## Discussions and Replies — Session VI

# DISCUSSIONS AND REPLIES

## SESSION VI

### Seismic Response of Embankment Dams

Fig. 1. Computed and Recorded Absolute Acceleration Responses of the Solid Phase in the Up/Downstream Direction at the Crest of the Santa Felicia Dam and the respective Fourier Amplitude Spectra (the computed response is plotted with a solid line)

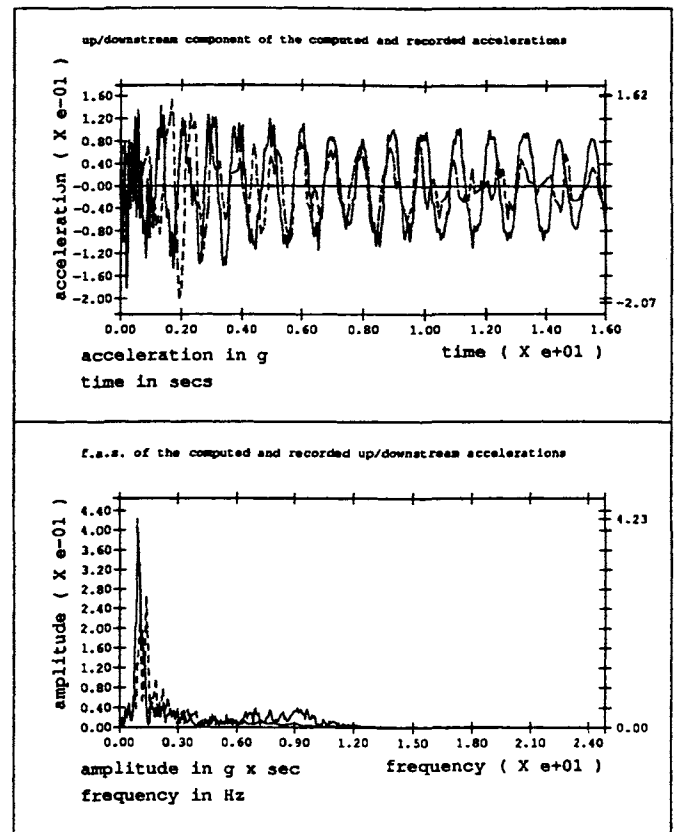
- In order to properly compare the computed and the observed accelerations it is very useful to use Density power spectral functions or Fourier Transform functions. Could the author present this type of graphics for both horizontal and vertical direction in the Santa Felicia and Long Valley Dams?

- The Fourier Amplitude Spectra of the computed and recorded absolute acceleration responses in the horizontal and vertical directions at the crests of the Santa Felicia and Long Valley Dams are given in the following along with the respective computed and recorded absolute accelerations.

Fig.1 N-value at dam body of upstream side ( Boring No. B-2)

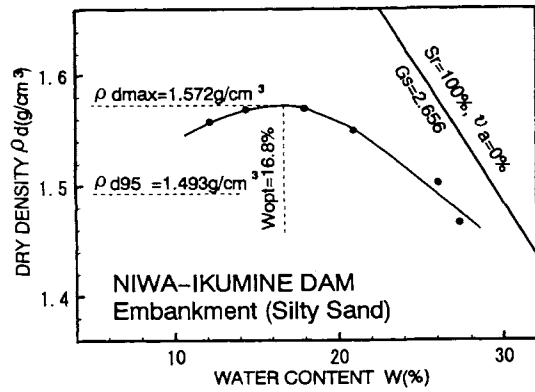
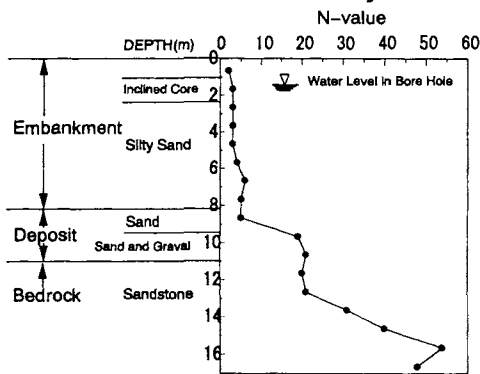
The paper provides some glimpse of the current Specifications of Highways and Bridges of Japan (1990) to calculate a safety factor against liquefaction. This gives an indication of the Japanese approach for determining zones that have potential for liquefaction triggering. The formula appears to be somewhat empirical and conservative considering a large fine content (FC) of 40% as the separating factor of two levels of resistance. Normally this order of fines in sand material would inhibit any strain softening or liquefaction. However, for the Niwa-Ikumie Dam the authors have shown that the embankment soils (silty sand) at depths from 2m to 9m liquefied and this has caused some settlement in the upstream slope. It appears that the liquefaction was mainly dictated by the very low N-values. The authors could have enhanced the quality of the paper by providing more detail on the observations and investigations such as grain size distribution of the embankment and foundation soils and profiles of N-values.

We apologize for in sufficiency of detail on the investigations for Niwa-Ikumine Dam. We supply more detail information on the drilling inspection and soil tests for Niwa-Ikumine Dam. Figure 1 shows the distribution of N-value by the drilling inspection at the dam body of upstream side. Figure 2 shows the distribution of grain size of embankment soil and deposit on riverbed. Figure 3 shows the result of compaction tests of embankment soil consisted in silty sand.
